AGENDA
MAY 7, 2019
CITY OF LAVON
PLANNING AND ZONING COMMISSION
SPECIAL MEETING
CITY HALL, 120 SCHOOL ROAD - LAVON, TEXAS
6:30 PM

**CITY OF LAVON
CITY COUNCIL
Agenda Brief**

RE: Final Plat and Final Engineering Plans
Traditions at Grand Heritage Phase 2
111 SF Lots, 2 Open Space Lots and City Dedication on 30.485 Acres.

Re: Traditions at Grand Heritage Phase 2, 111 Lots, 3 open space, 30.485 Acres
Final Plat

STORM SEWER PLAN & PROFILE
 DITCH D-1
 TRADITIONS AT GRAND HERITAGE PHASE 2
 CITY OF LAVON
 COLLIN COUNTY, TEXAS

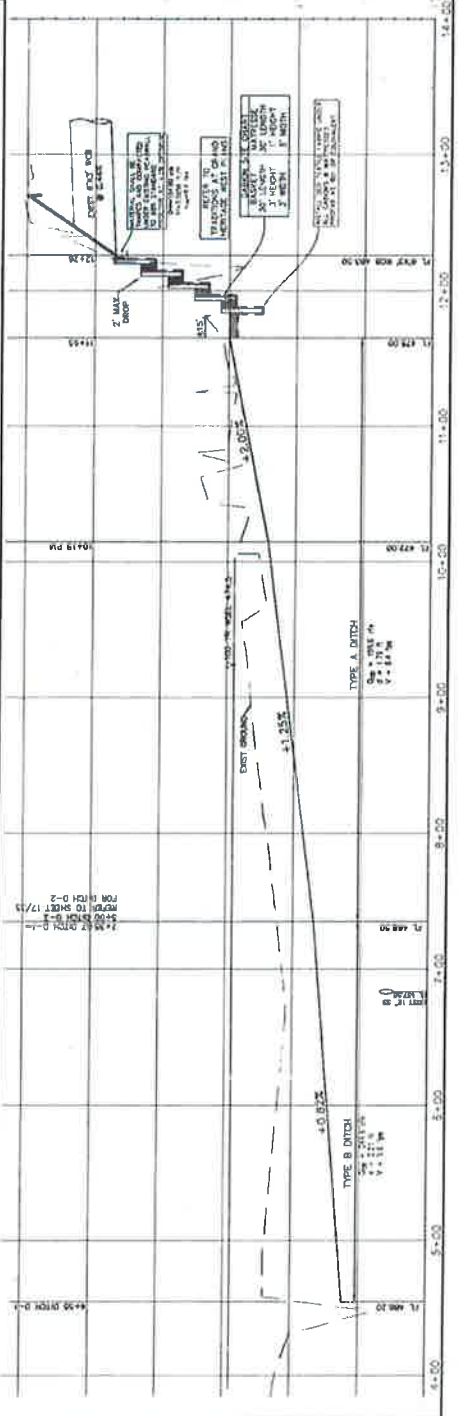
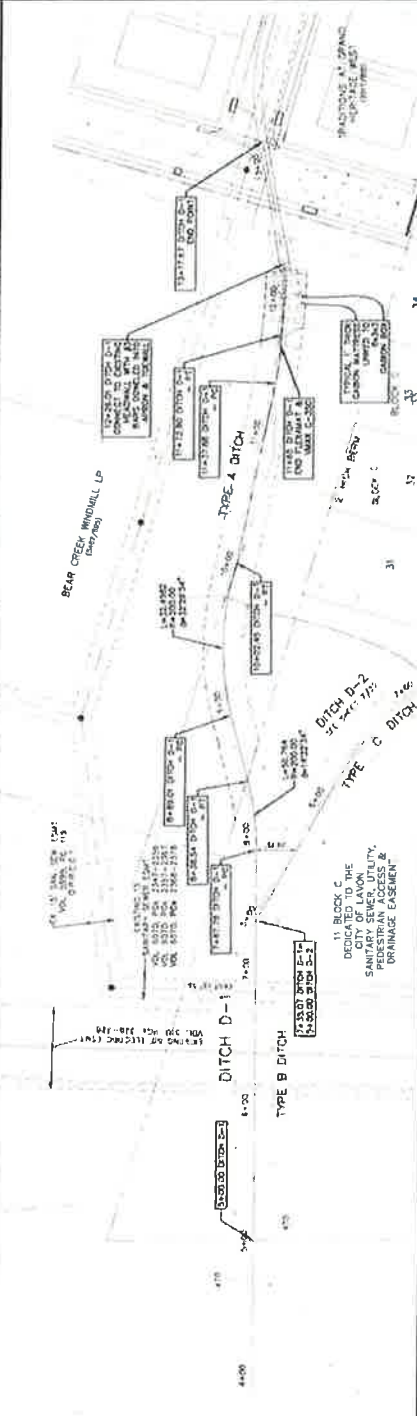
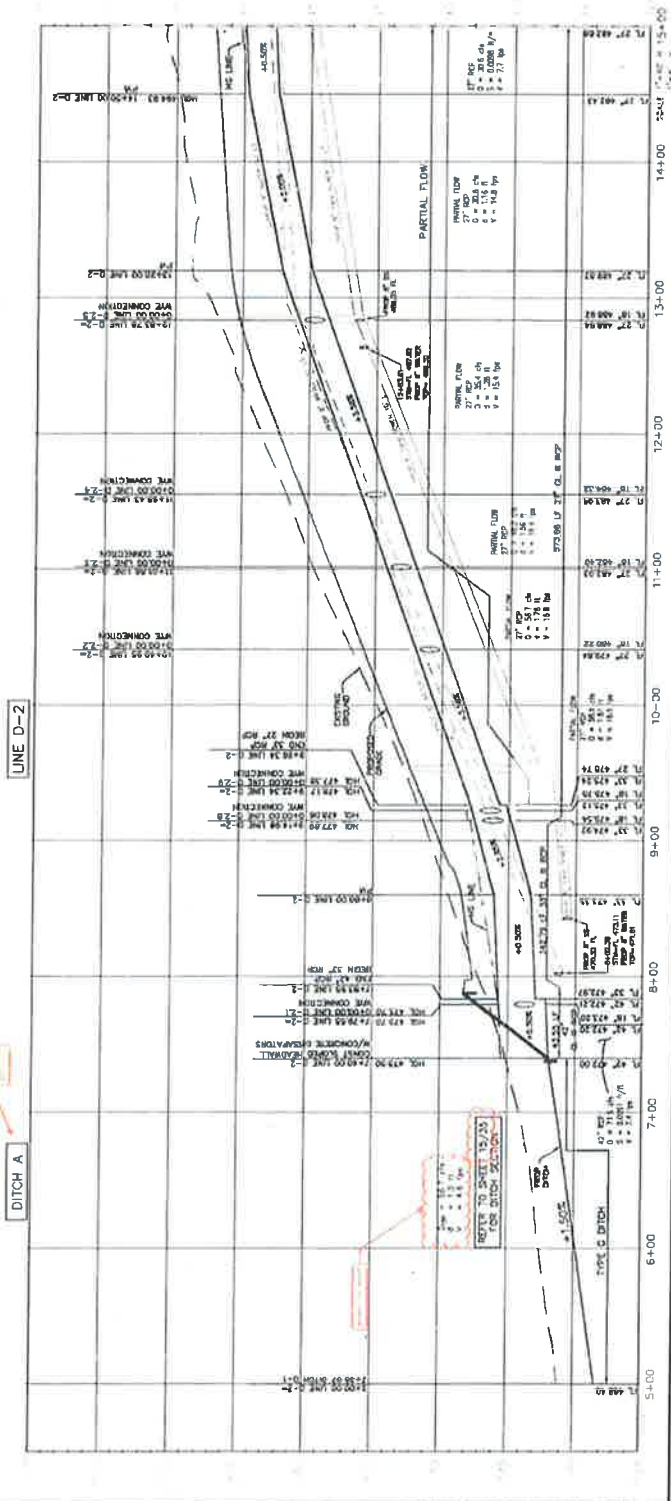
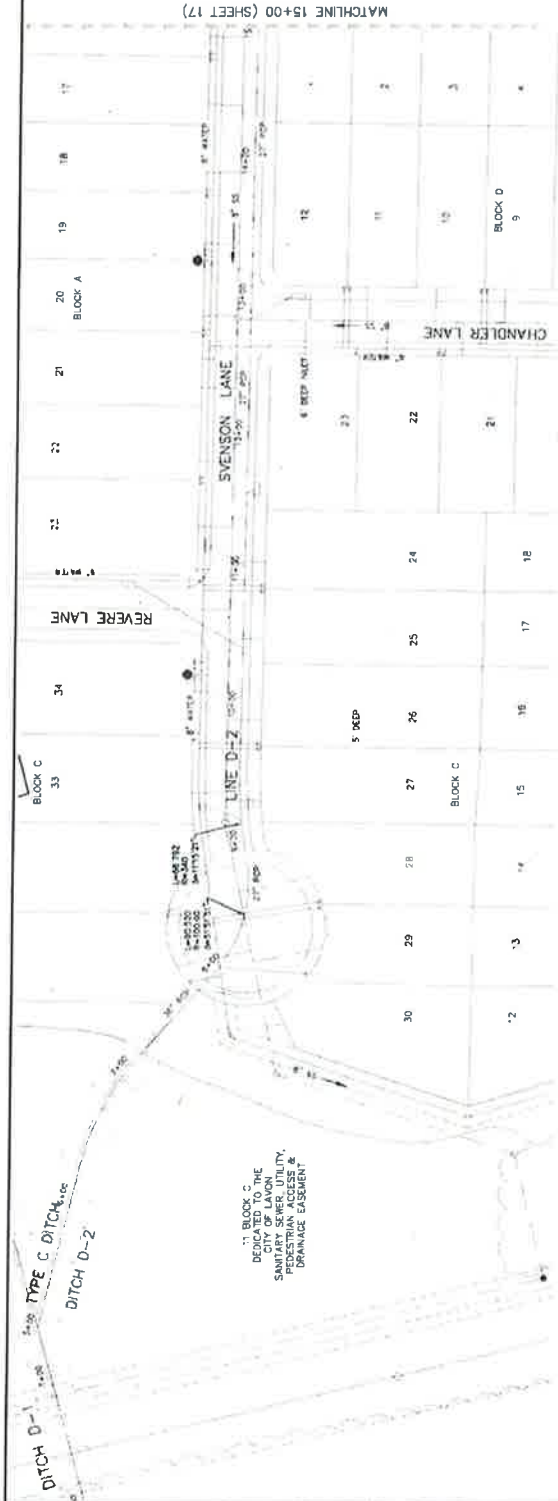
Storm Sewer Plan & Profile (Sheet 16 of 31)

19. The existing ditch from the Bear Creek WWTP should be shown intersecting Ditch D-1. Erosion control will be required for this WWTP ditch to a point 5' beyond the top bank of Ditch D-1.
We have shown the existing ditch coming from the WWTP and have shown erosion control installation as requested.

20. Ditch D-1 appears to daylight at Bear Creek beyond the property line. A drainage easement will be required from the property owner.
The property is described to be the approximate centerline of Bear Creek which has varied since the original deed was filed.

21. Details should be provided for erosion control at Bear Creek.
Erosion control as well as grading has now been shown at both the direct connections to Bear Creek. We have also added a note directing the contractor to alert the Engineer prior to making these connections to review and make recommendations on the actual connection prior to installation.

22. Since there are several versions of the erosion control (Green VMAX & Flexamat), the Engineer should provide additional information such as product number, required velocity and soil shear capabilities, etc.
The Green Vmax C350 is specified for the product. The Flexamat has only one spec. that we are aware of. We state in the notes that installation shall follow the manufacturer's specifications. These products both are known for use with erosive velocities and their soil shear strengths.

Storm Sewer Plan & Profile, Ditch D-1 (Sheet 15 of 30)

10. Ditch D-1 will be within a 30' drainage easement. A copy of the executed easement should be provide to the City prior to approval of the Final Plat.

11. Erosion control at the ditch outfall to be field determined prior to connection to Bear Creek. The final erosion control design should be provided ot the City for review and approval.

12. Any work under the Garland Light & Power easement will require a permit. This must be procured prior to any construction activities.
13. Per the Engineer's response to previous comments, the property line is the approximate centerline of Bear Creek, but the creek has varied since then. However, it appears that the ditch extends beyond the platted property line shown (which is called out as approximate centerline creek, but does not appear to be), which would imply it extends into the adjacent property. The adjacent Crestridge Meadows Phase 1 Final Plat also calls out the common line meanders along Bear Creek. That being said, it appears that as long as the improvements are on the north side of Bear Creek, there would not be a need for any easements.

STORM SEWER PLAN & PROFILE
 LINE D-2
 TRADITIONS AT GRAND HERITAGE PHASE 2
 CITY OF LANYON
 COLLIN COUNTY, TEXAS

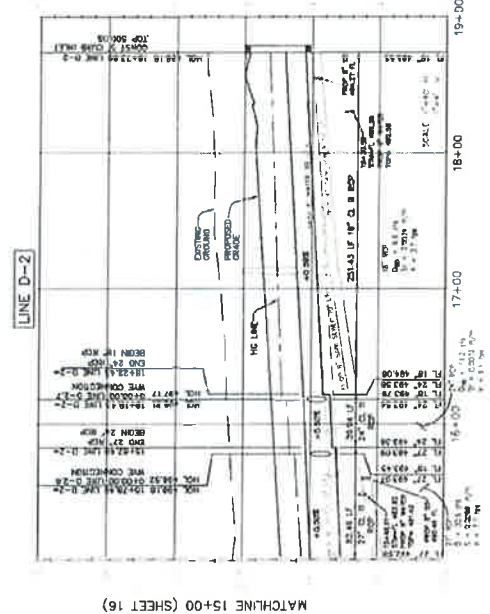
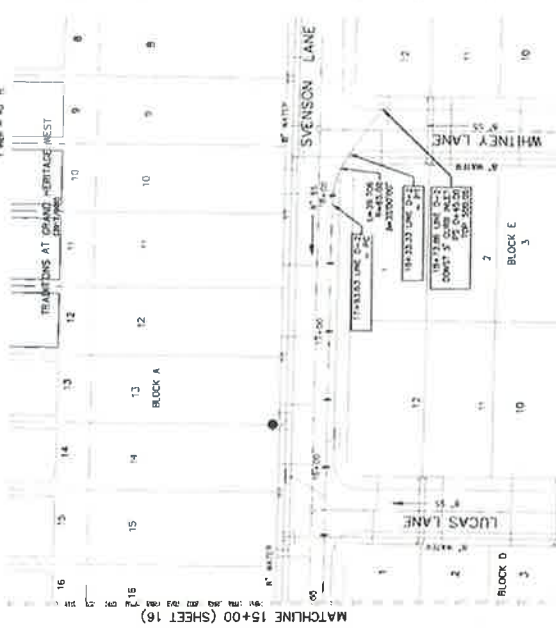
Storm Sewer Plan & Profile (Sheet 16 of 30)

14. There is a note on "Ditch A" that does not appear to be needed on this sheet. The Engineer should verify.
15. There is some flow data shown above the ditch in the profile. It is not clear as to what this data is.

CBU, STREET LIGHT & SIGNAGE PLAN

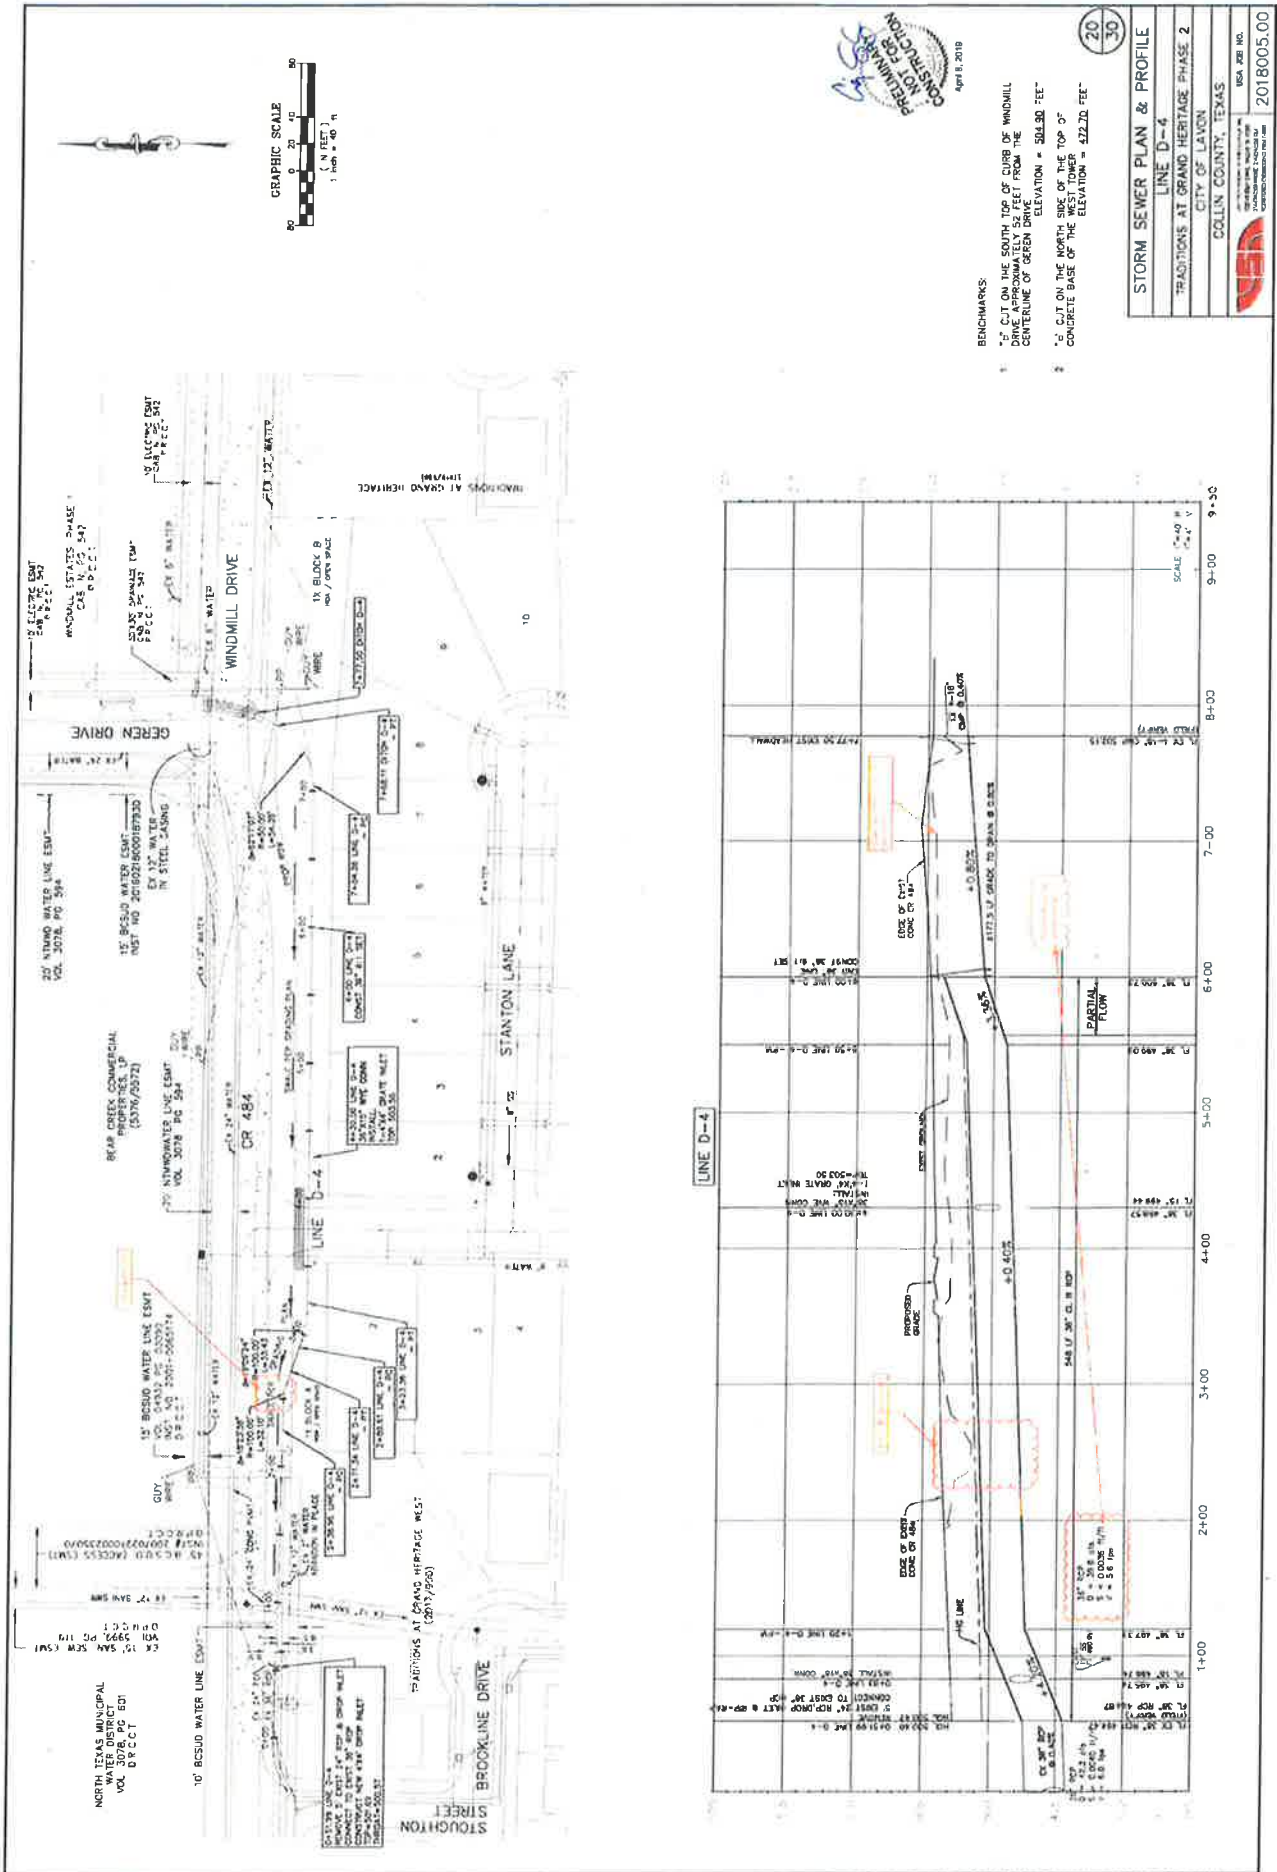
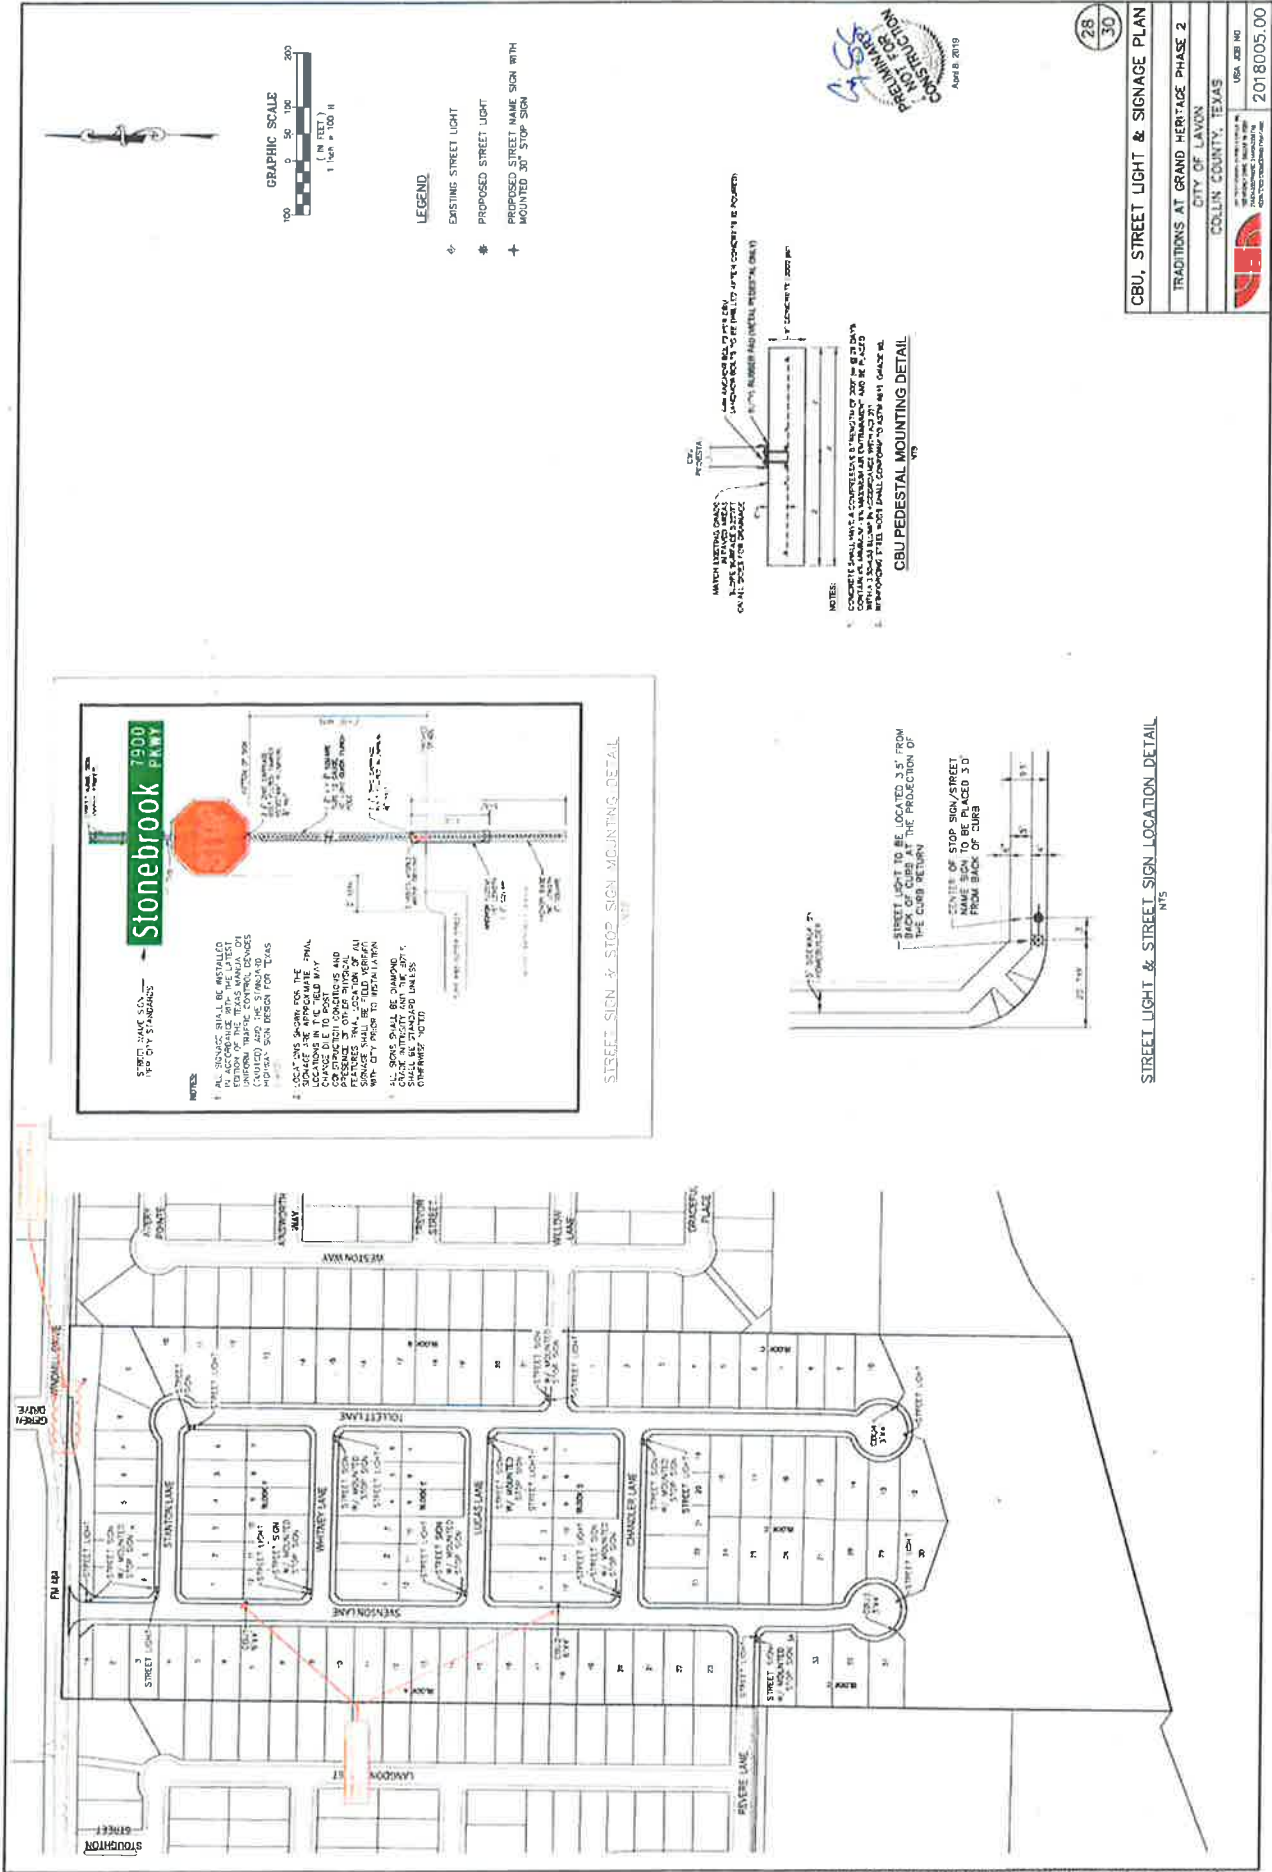
CBU, Street Light & Signage Plan (Sheet 29 of 31)

20. A street light is required at the location of any cluster mailboxes. The street light shall be within 50' of the mailbox cluster.

21. The metal beam guardrail at Geren should be extended to beyond the west edge of Geren to protect houses in the event of a vehicle failing to stop. The west end shall be a terminal anchor section.
